# Administrative Action

## Preliminary Subdivision

**Case File / Name:** **S-21-12 / Ramblewood Lantern – Phases 1, 2, 3 and 4 Revisions**

**SUBJECT:** S-21-12 / Ramblewood Lantern – Phase 4 Revisions

**S-21-12/Ramblewood Lantern - Phase 4 Revisions – Preliminary Subdivision Plan**

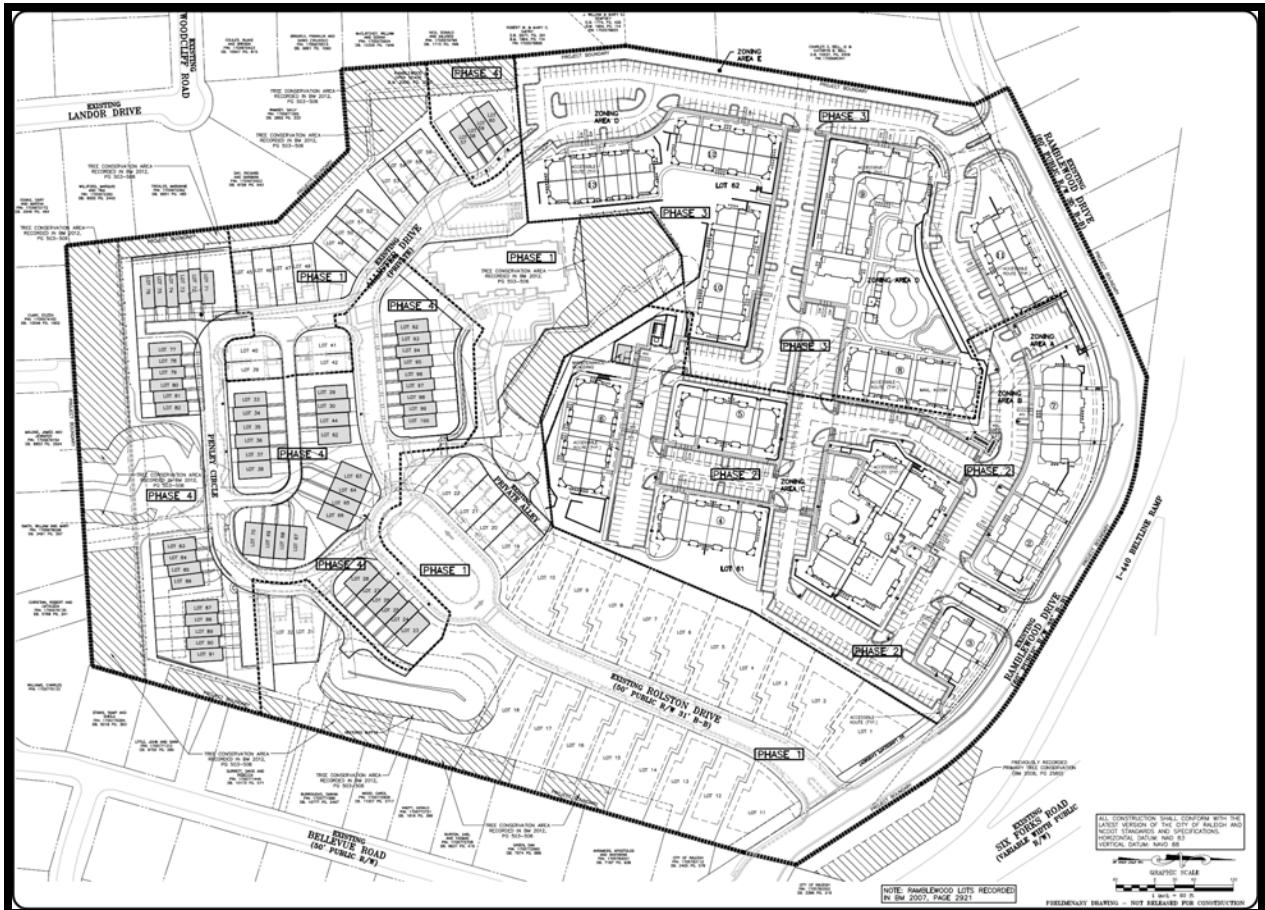
- (1) That prior to issuance of a land disturbing permit for phase 4, private drainage easements are required for all storm drainage and must be recorded prior to as-built certification. This easement must provide access to the BMP's from a public right of way;

- (5) That construction plans for public improvements and private streets be approved by the Public Works Department; These construction drawings shall be submitted for all 4 phases. Lots 57-60 (townhouse lots) shall be shown and re-recorded in phase 1. Any lots recorded in previous phases shall be re-recorded prior to any permit issuance.

- (8) That the 40 foot and 100 foot wide natural protective yards specified in accordance with zoning conditions 4 and 5 of Z-38-05 are shown on the plat.;

- (a) Water service to lot 86 be made behind the backflow device.
- (b) Water service/meter for lot 28 and all lots provided on the same side as the address.
- (c) The proposed backflow for lots 71-76 moved outside the private easement and/or private right-of-way.
- (d) The proposed easement between lots 87 & 88 as private.
